## Agenda Item # 5

SUB-003552-2025

Planning Commission  
December 18, 2025

Counts Estate Subdivision

# DETAIL SITE PLAN

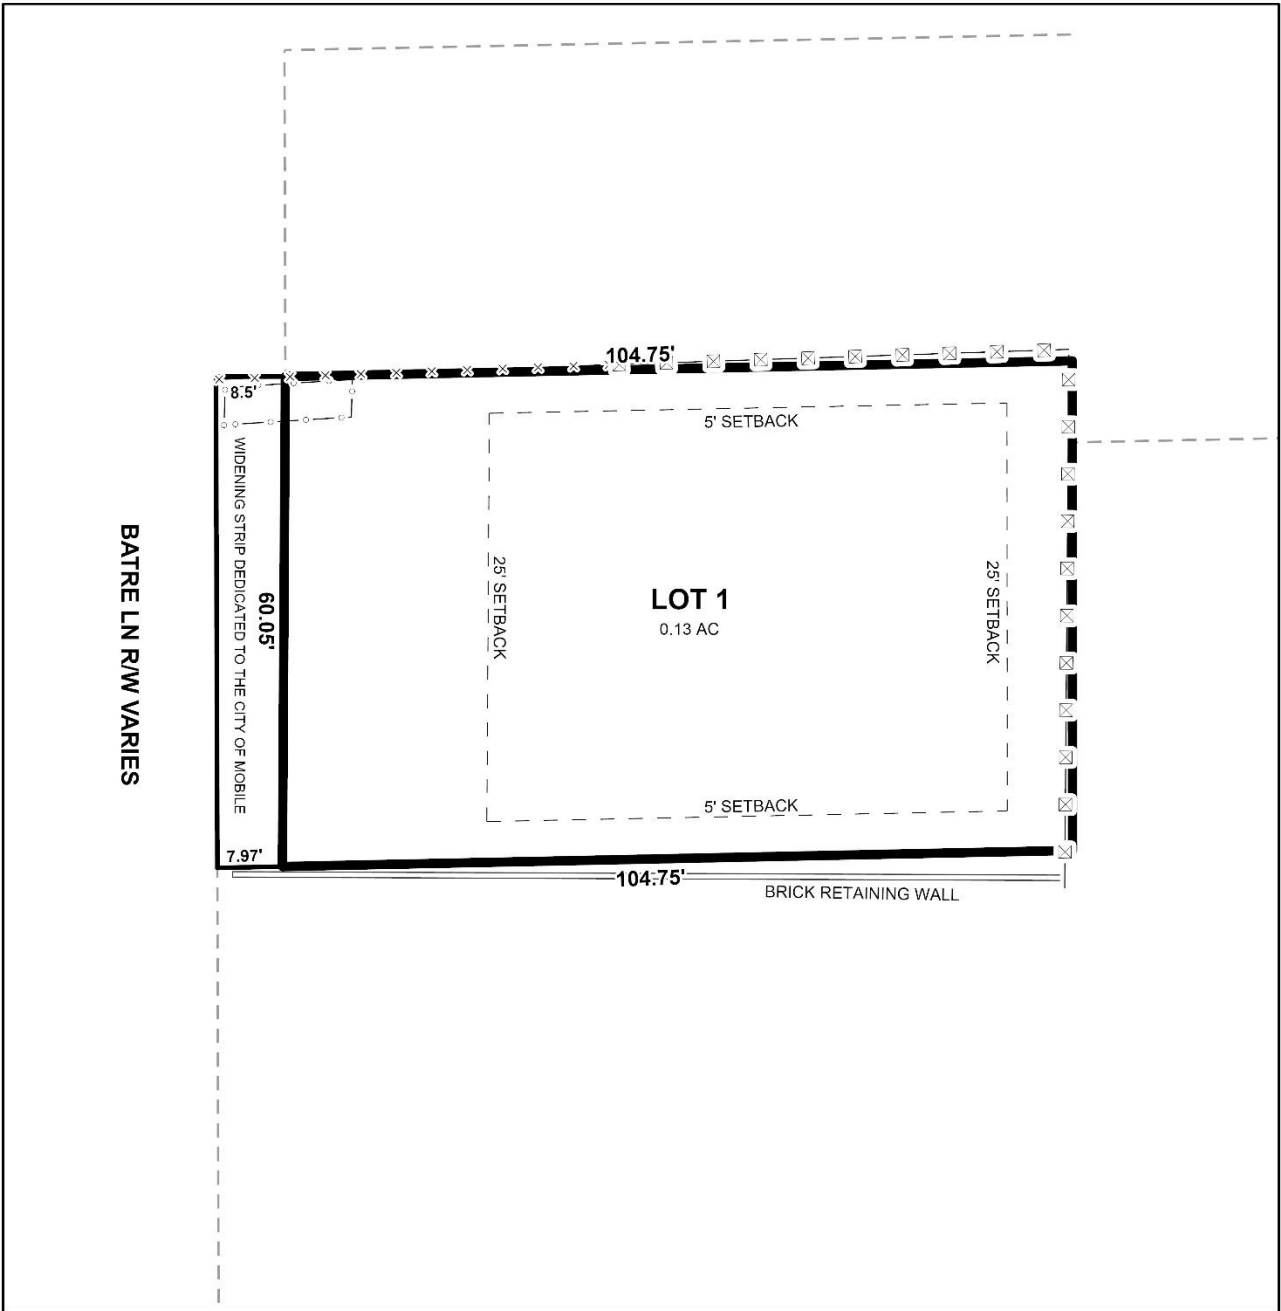
- B. Show and label the POB.
- C. Clearly show and label the monuments set and found at all corners and the dedicated ROW.
- D. Provide the bearing and distance labels for the est property line of the proposed subdivision.

- E. Show and label the area dedicated to public ROW in acres and square feet.
- F. Revise NOTES 8 to read as follows – “As shown on the 1984 aerial photo LOT 1 will receive the 900 sf of historical credit of existing (1984) impervious area towards stormwater detention requirement per Mobile City Code, Chapter 17, Storm Water Management and Flood Control) and the 4,000 SF credit provided to the original SF residential lot as follows: LOT 1 – 4,900 sf. Stormwater detention will be required for any additional impervious area that exceeds the allowable credit for that LOT.

The lot fronts Batre Lane, a minor street with curb and gutter improvements requiring a 50-foot-wide right-of-way. The preliminary plat depicts varying right-of-way widths along Batre Lane at this location; however, the applicant proposes dedication sufficient to provide a minimum of 25 feet from the roadway centerline. As such, no additional dedication should be required, but the proposed dedication must be retained on the Final Plat, if approved.

The proposed lot does not meet the minimum area requirements of Article 2, Section 64-2-5.E. of the Unified Development Code (UDC) for lots served by public water and sanitary sewer within the R-1, Single-Family Residential Suburban District. This lot configuration is common in the surrounding neighborhood and may support consideration of a waiver of Section 6.C.2(a) of the Subdivision Regulations.

The lot is properly labeled with its area in both square feet and acres on the preliminary plat, as required by Section 5.A.2(e).4. of the Subdivision Regulations. If approved, this information should be retained on the Final Plat, adjusted for any required dedication; alternatively, a table providing the same data is acceptable.

A 25-foot minimum front yard setback is illustrated along Batre Lane, as required by Section 6.C.8. of the Subdivision Regulations and Article 2, Section 64-2-5.E. of the UDC. This information should be retained on the Final Plat, if approved.

Side and rear setbacks are shown on the preliminary plat, though they are not required by the Subdivision Regulations. If approved, these setbacks should be removed from the Final Plat.

1. Retention of the proposed right-of-way dedication along Batre on the Final Plat, as depicted on the preliminary plat;
2. Retention of the lot's size in both square feet and acres, or provision of a table on the Final Plat with the same information;
3. Retention of the 25-foot minimum front yard setback line along Batre Lane;
4. Removal of the side and rear setbacks;
5. Compliance with all Engineering comments noted in this staff report;
6. Placement of a note on the Final Plat stating all Traffic Engineering comments noted in this staff report;
7. Compliance with all Urban Forestry comments noted in this staff report; and,
8. Compliance with all Fire Department comments noted in this staff report.
